**Re: Sonic Drive-In
Project Address
Traffic Circulation Layout**
Architect's Stamp 6-2-17 (K11D047)

SITE PLAN, DESIGN DATA
AND NOTES

SONIC
6420 CENTRAL AVE S.W.
ALBUQUERQUE, NEW MEXICO

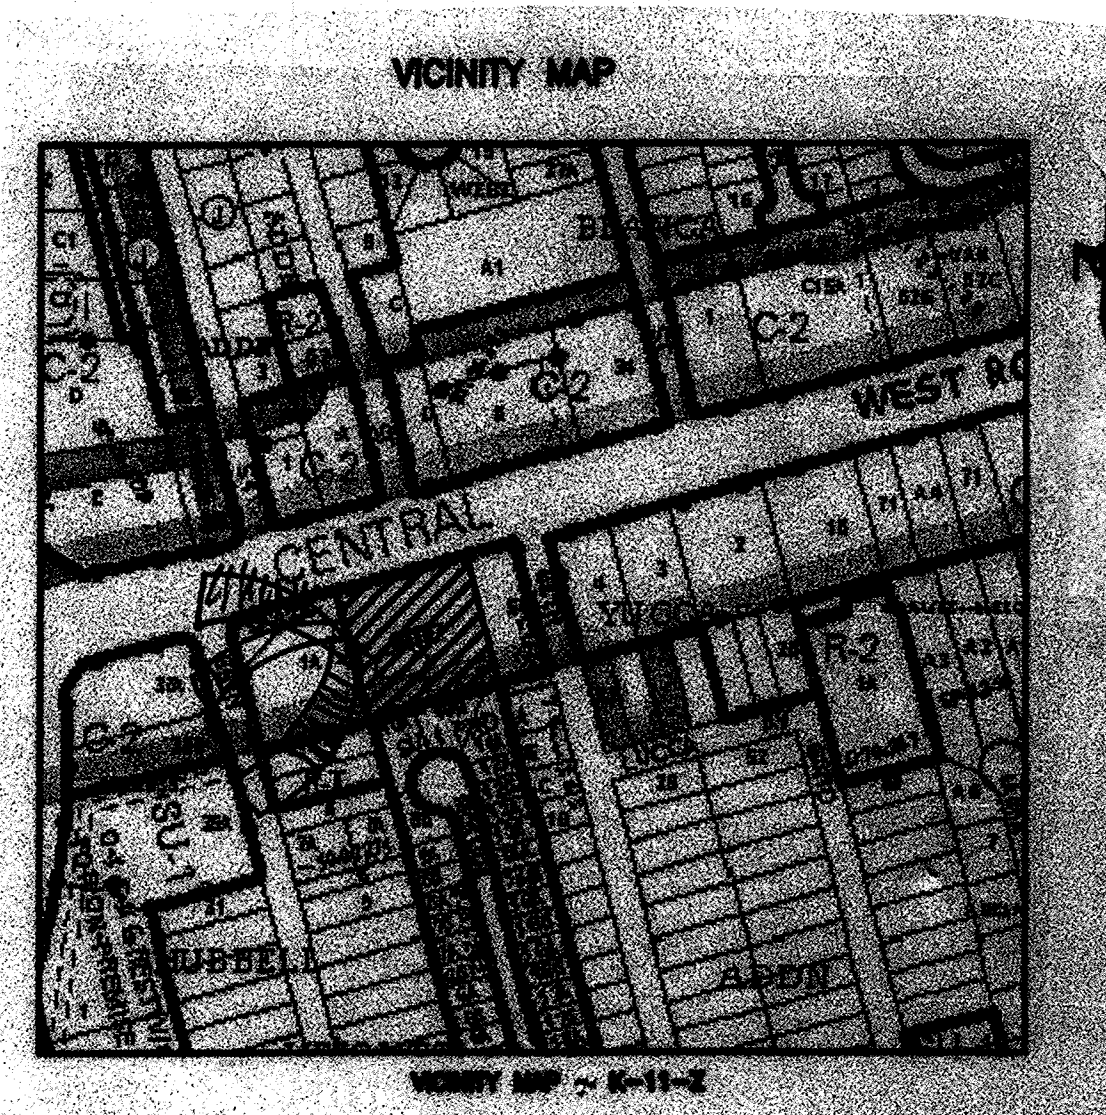
The ADA accessible parking sign must have the required language per 66-7-352.4C NMSA 1978 "Violators Are Subject to a Fine and/or Towing." Please call out detail and location of HC signs.

The ADA access aisles shall have the words "NO PARKING" in capital letters, each of which shall be at least one foot high and at least two inches wide, placed at the rear of the parking space so as to be close to where an adjacent vehicle's rear tire would be placed. (66-1-4.1.B NMSA 1978)

Motorcycle parking spaces shall be designated by its own conspicuously posted upright sign, either free-standing or wall mounted per the zoning code.

Per the zoning code, a 6 ft. wide ADA accessible pedestrian pathway is required from the public sidewalk to the building entrances. Please clearly show this pathway and provide details.
